## ADDENDUM #10

**Western Slope Food Bank of the Rockies**  
698 Long Acre Drive

**Bid Package #3 – Foundations**  
**Bid Package #4 – Above Ground**

Addendum #10 is issued to coordinate structural elements with the metal building, architectural details and to add steel to support the stair to the 2<sup>nd</sup> floor offices. The bottom layer of vapor retarder is deleted under the insulated slab and the transition details for the vapor retarder are clarified.

### COVER SHEET, GENERAL NOTES, WALL TYPES

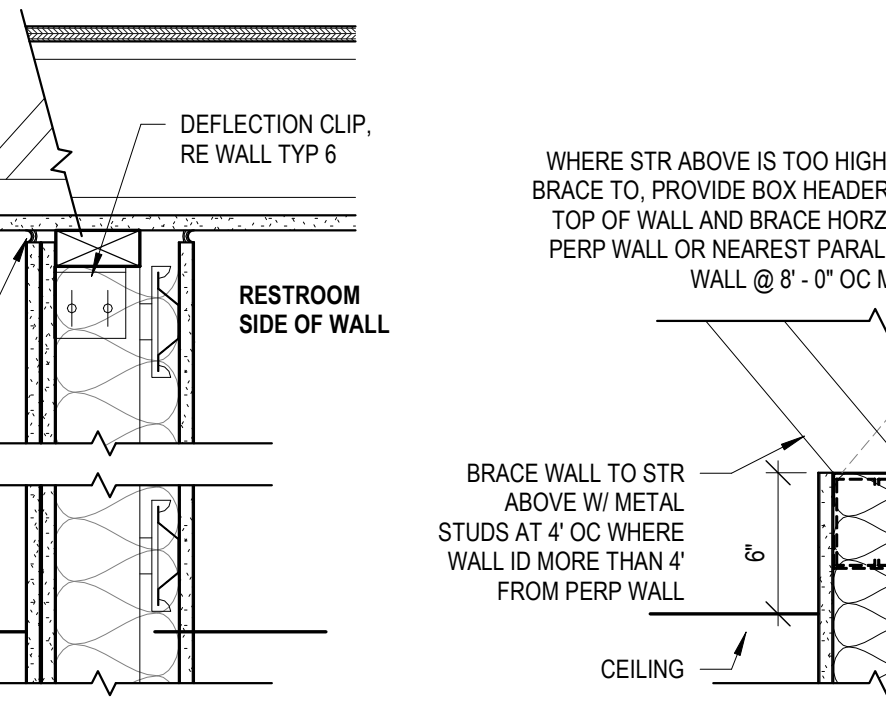
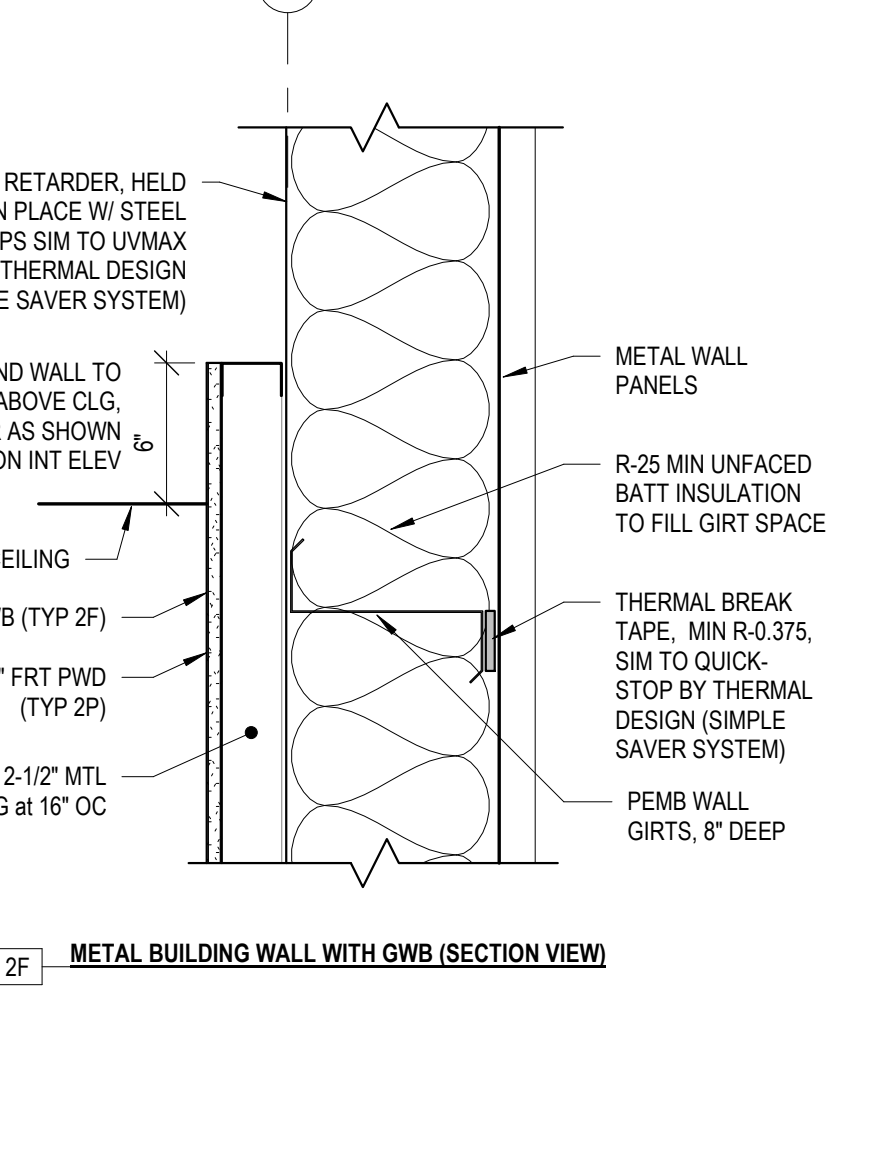
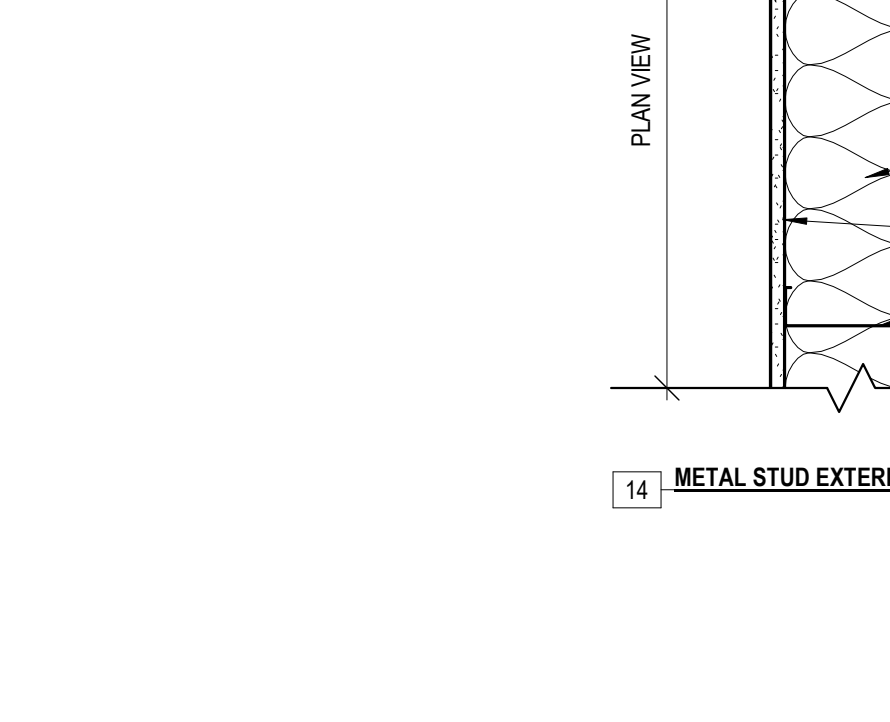
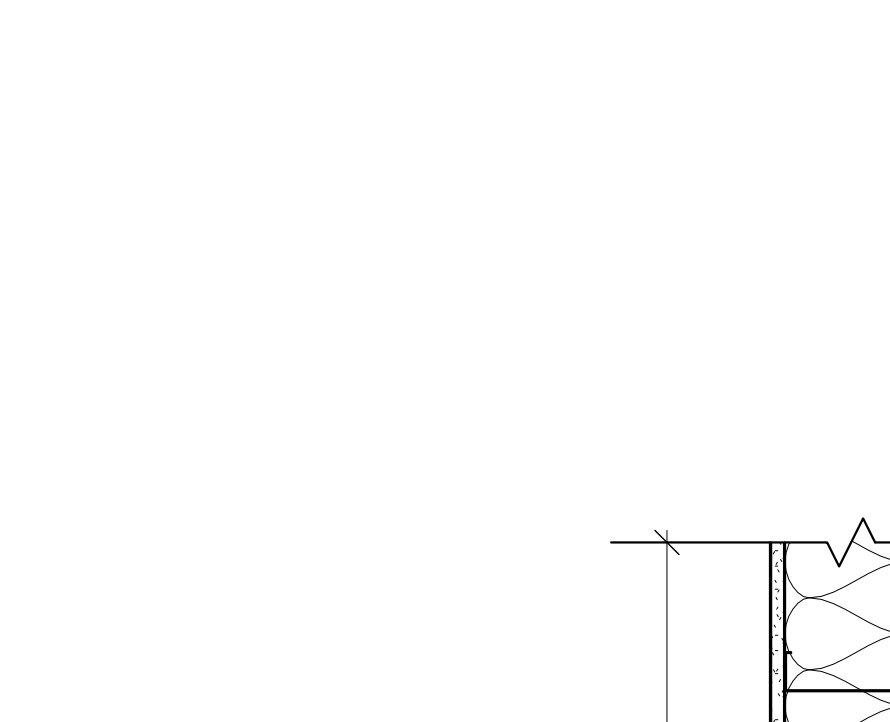
- ADD10-2 BP#3, Sheet T001 Cover Sheet, General Notes, Wall Types: Change detail Wall Types 3 and 4 per attached reissued sheet T001,
- ADD10-3 BP#4, Sheet A001 Notes, Symbols, Abbreviations and Wall Types: Change Wall Types 3 and 4 per attached reissued sheet A001.
- ADD10-4 BP#3, Sheet S102 Foundation Plan – West: Delete sheet and replace with attached reissued sheet S102.
- ADD10-5 BP#4, Sheet 104 Mezzanine and Low Roof Framing Plan: Delete sheet and replace with attached reissued sheet S102.
- ADD10-6 BP#4, Sheet S200 Typical Foundation Details: Modify not at Typical Slab Joint Detail per attached revised sheet S200.
